# 2023 Recharge Master Plan Update

Chino Basin Watermaster

Project No. 941-80-22-11

Figure 1-3. Streambed Infiltration and Managed Recharge of Stormwater in the Chino Basin, 1978-2022

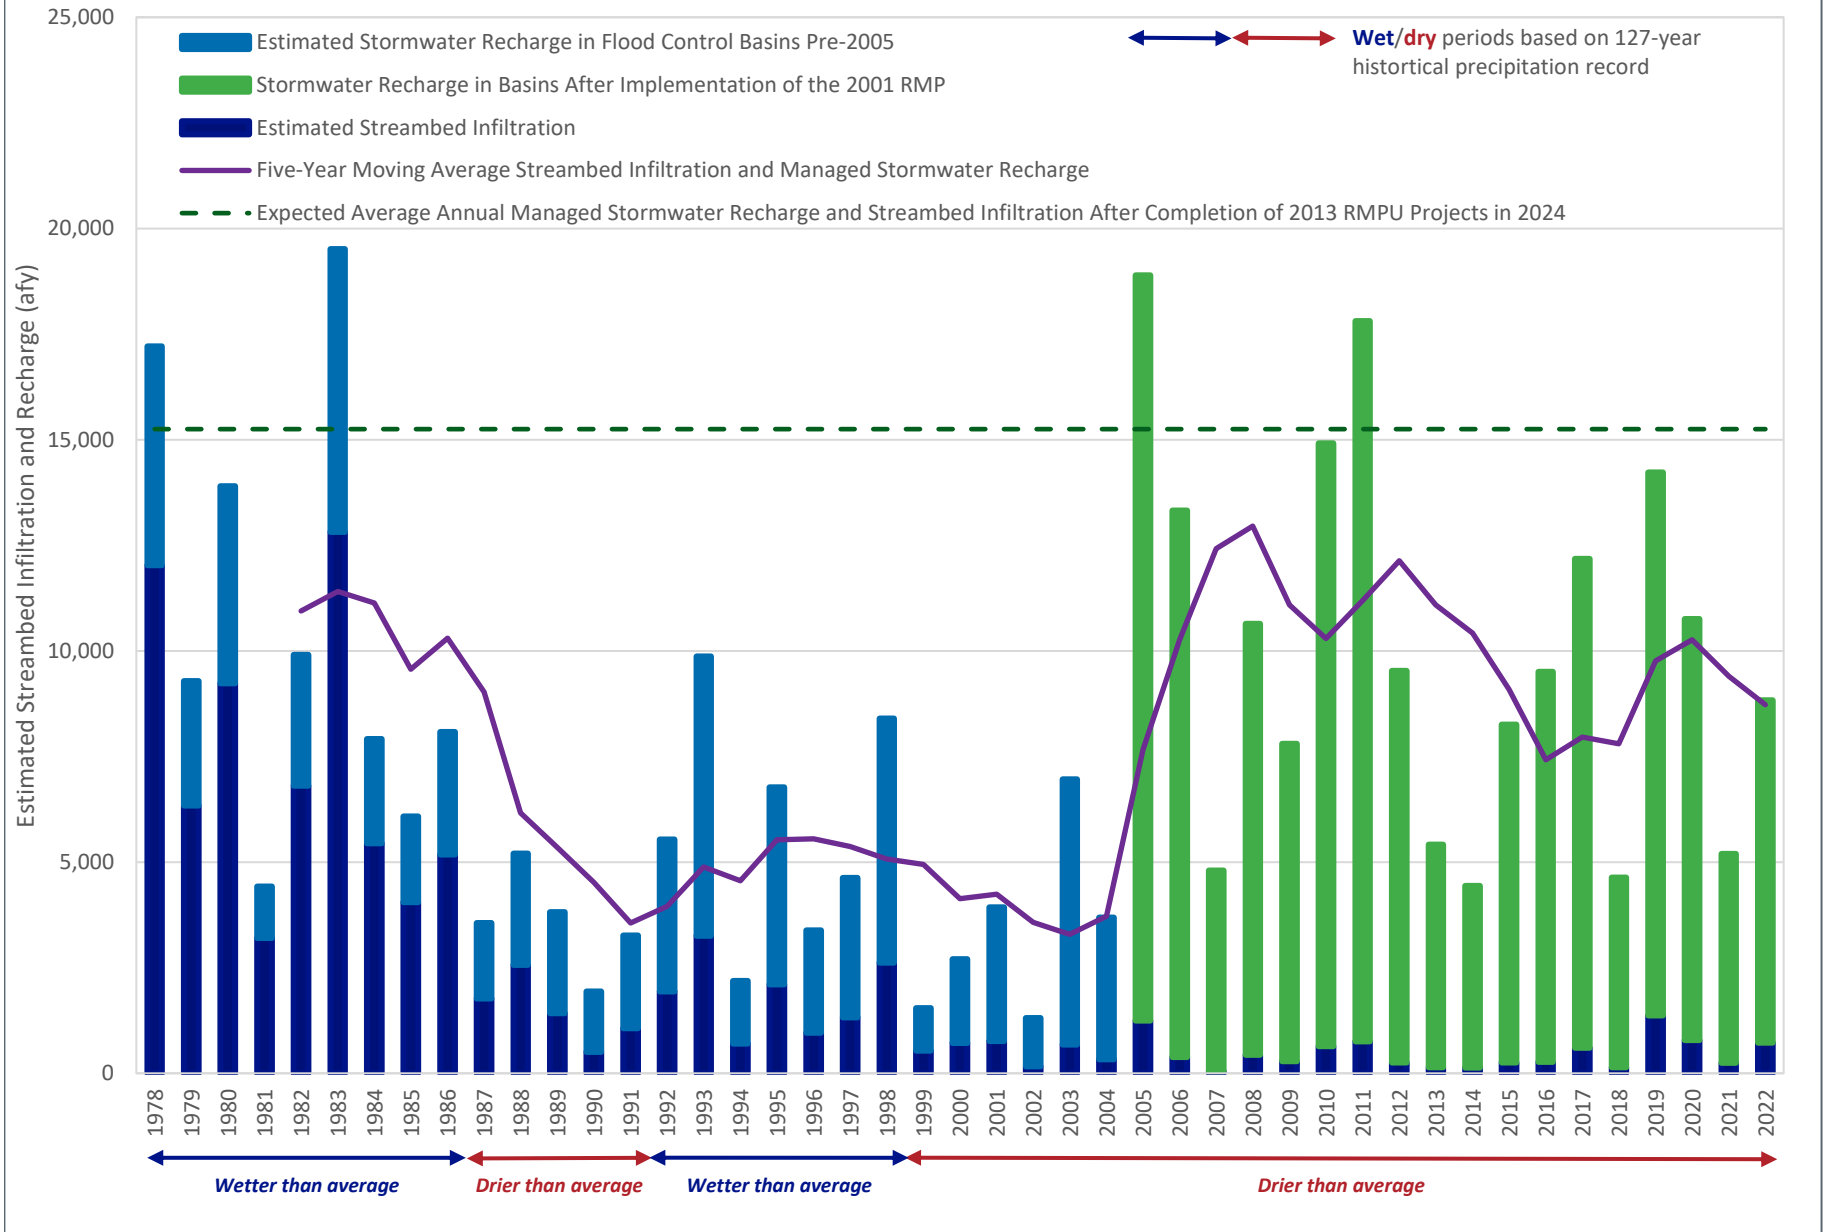
### **Comment 1 – Page 1-6: “Figure 1-3. Estimated Streambed Infiltration for the Santa Ana River Tributaries in the Chino Basin and New Recharge Resulting from Recharge Master Plan Implementation, 1978-2018”**

See above comment re Figure 1-3. We recommend this be rewritten to recognize the activities of the Chino Basin Water Conservation District in recharging stormwater and dry-weather runoff prior to 2004 and up to today.

See above comment re Figure 1-3. We recommend this be rewritten to recognize the activities of the Chino Basin Water Conservation District in recharging stormwater and dry-weather runoff prior to 2004 and up to today.

Figure 1-3 has been updated to show all historical managed stormwater recharge.

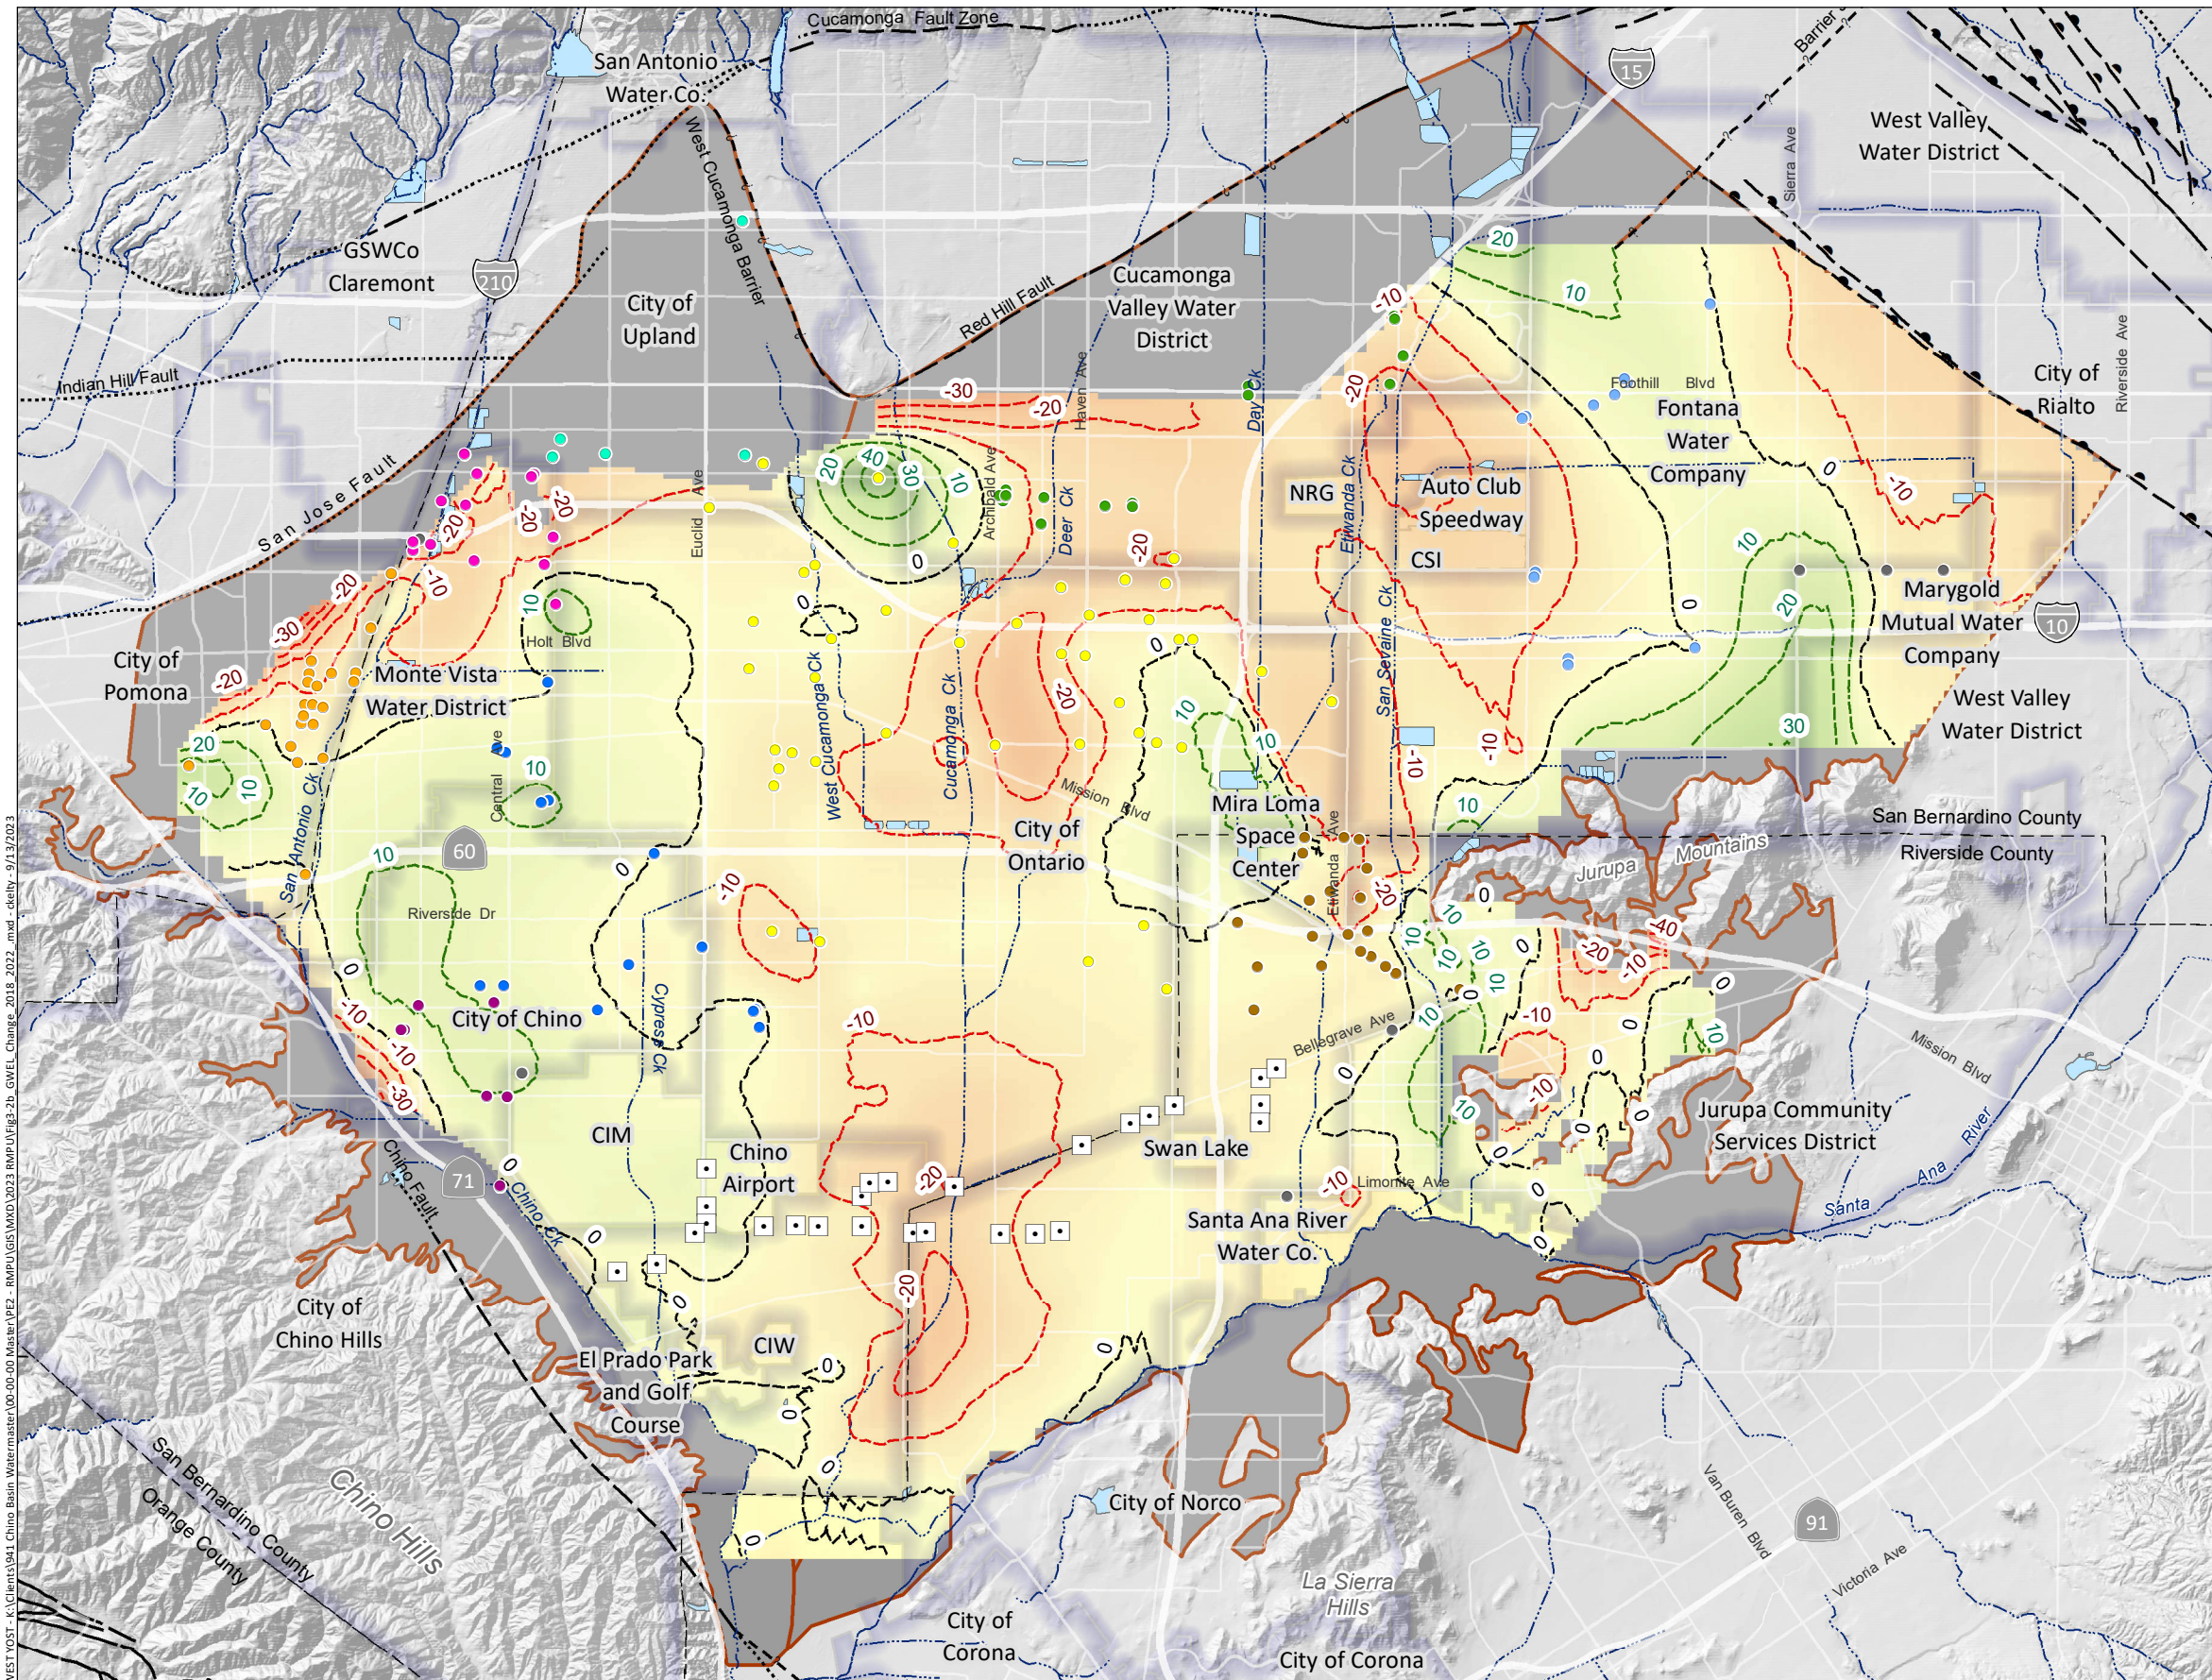
**Comment 10 – Figure 3-2c.**

Figure 3-3. Historical Groundwater Discharge from CCWF (FY 2004/05 to FY 2017/18)

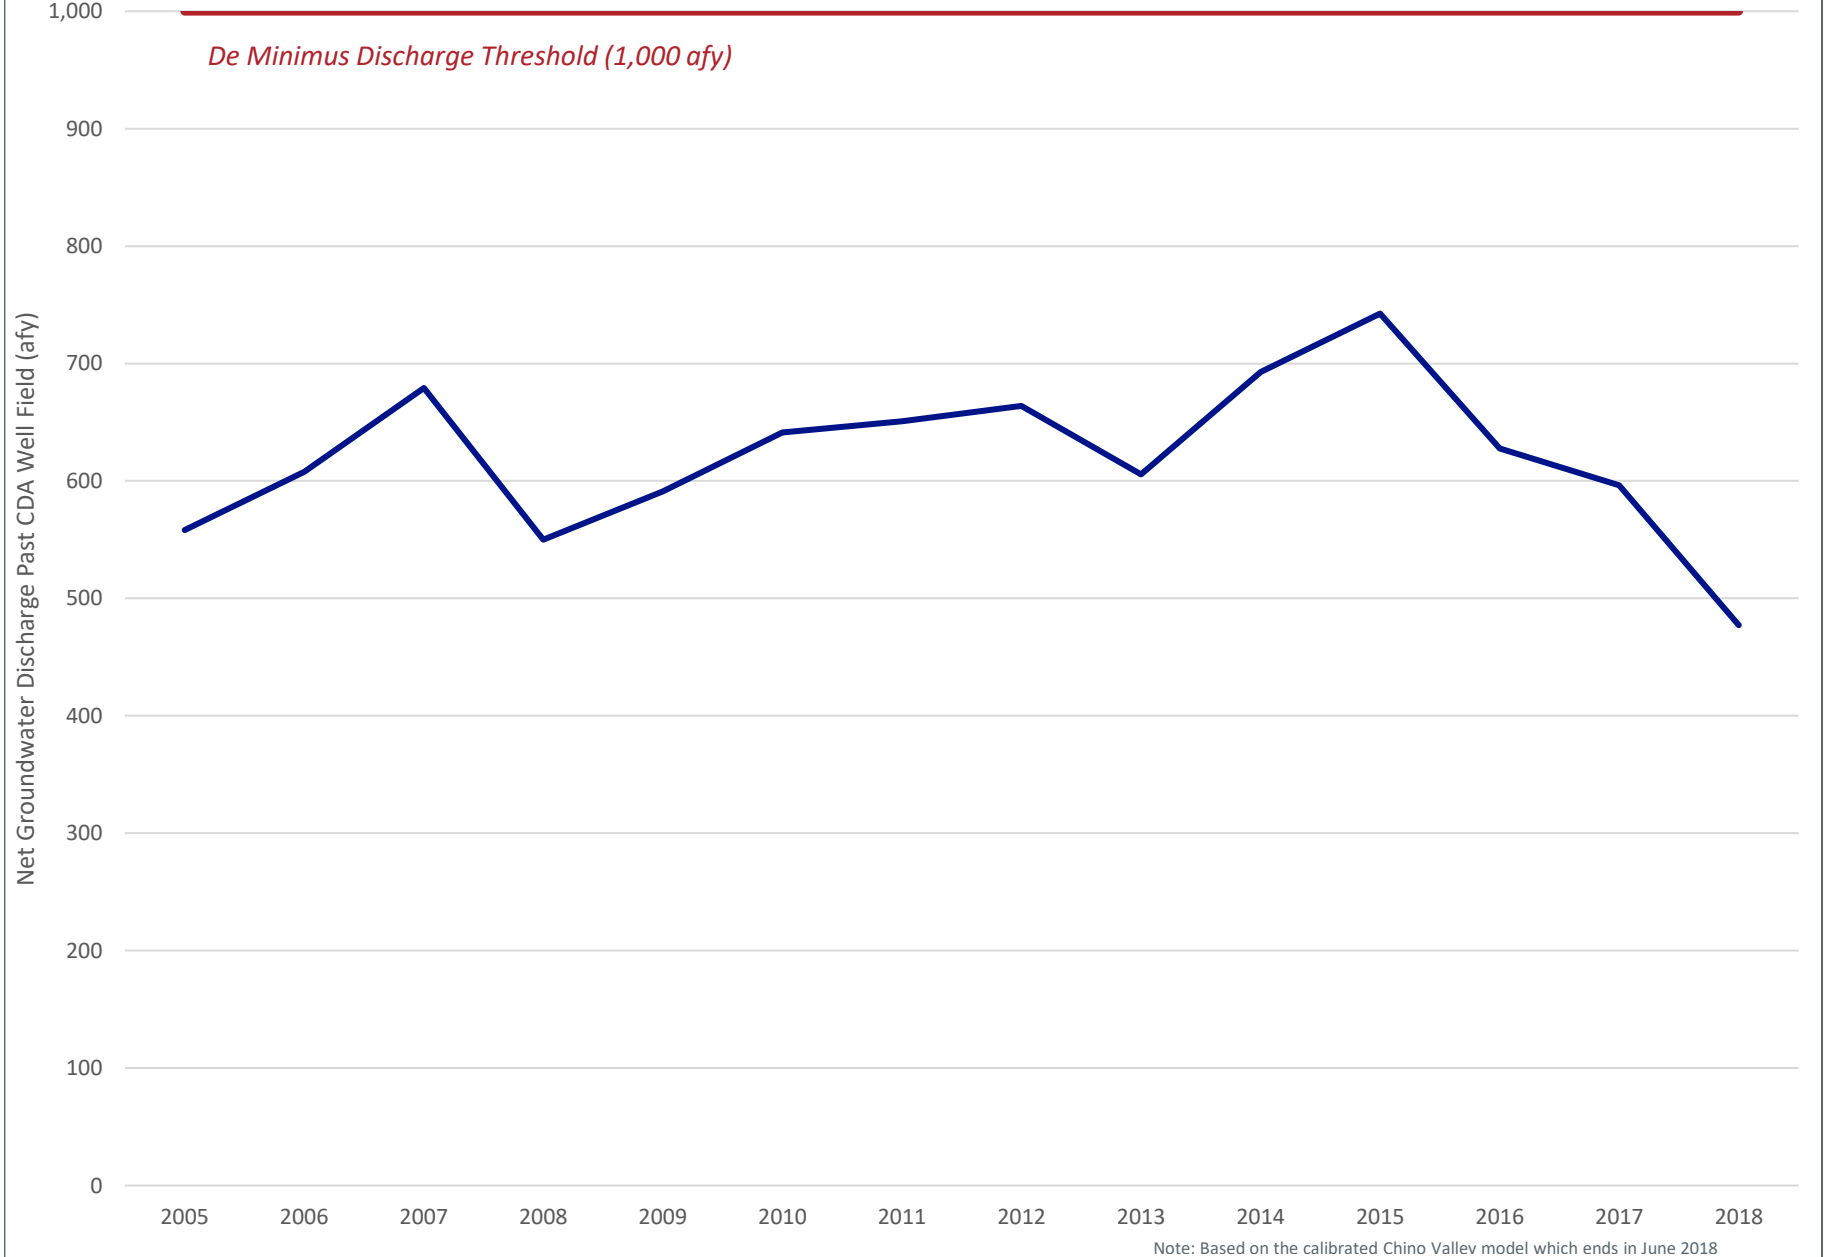
Figure 3-3 shows through 2018 and narrative states through 2023. Include note regarding model timeline.

The narrative has been updated to clarify that Figure 3-3 shows data through 2018 and that information regarding hydraulic control from 2018 to 2023 is based on the Chino Basin OBMP Maximum Benefit Annual Reports.

Figure 4-1. Comparison of Aggregate Water Demands in the Chino Basin for Various Planning Investigations

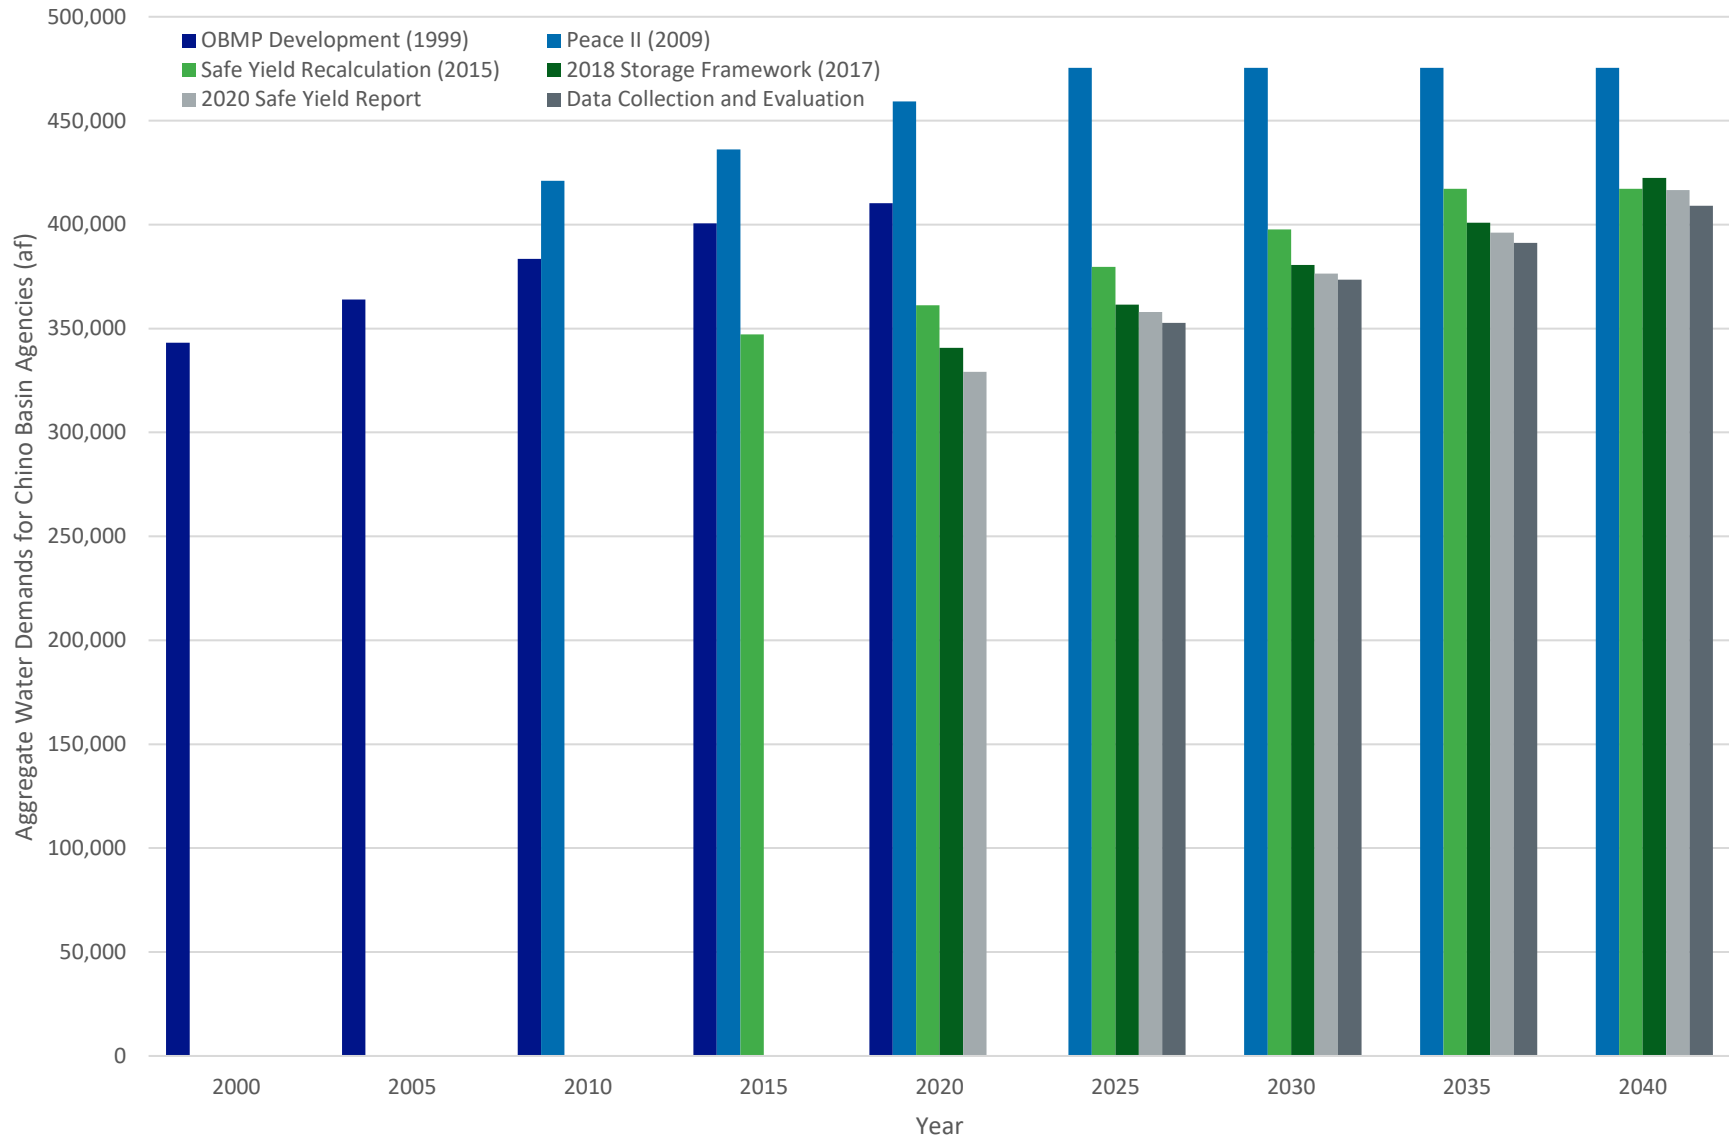
#### Comment 6 – Figure 4-1

**Comment 11 – Figure 4-1.**

Figure 4-1 was updated.

Figure 4-1 was updated.
